METROPOLITAN GOVERNMENT OF NASHVILLE AND DAVIDSON COUNTY

STAFF RECOMMENDATION
202 Manchester Avenue
February 19, 2020

Application: New Construction—Addition and DADU
District: Eastwood Neighborhood Conservation Zoning Overlay
Council District: 06
Base Zoning: R6
Map and Parcel Number: 08306013700
Applicant: S. Mitchell Hodge, Architect
Project Lead: Melissa Baldock, melissa.baldock@nashville.gov

Figure 4. MHZC's staff's illustration of the parts of the addition that are two feet (2') and four feet (4') taller than the histori house.

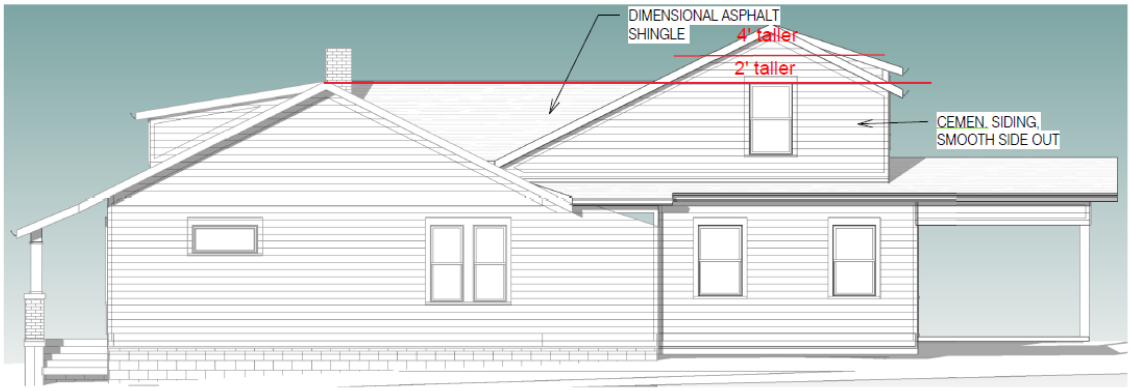
The addition ties into the back of the historic house at its ridge, but later rises to be four feet (4') taller than the historic house. The design guidelines allow for additions to be up to four feet (4') taller at a point more than forty feet (40') back from the front of the house when the going taller is the "only option." Because this house could have a ridge raise, if the applicant wanted one, the Commission has regularly approved additions to one and one-and-a-half story houses like this one that are two feet (2') taller.

In this case, staff is supportive of the four foot (4') taller portion of the addition for a few reasons. The taller portion is fully inset two feet (2'), and it has relatively modest depth. More importantly, the portion of the addition that extends taller than the house is just approximately sixteen feet (16'), and the depth of the addition that is more than two feet (2') taller than the house is just approximately eleven feet (11') (Figure 4). The relatively modest footprint of the addition and the design's minimizing of the taller portion of the addition make it appropriate.
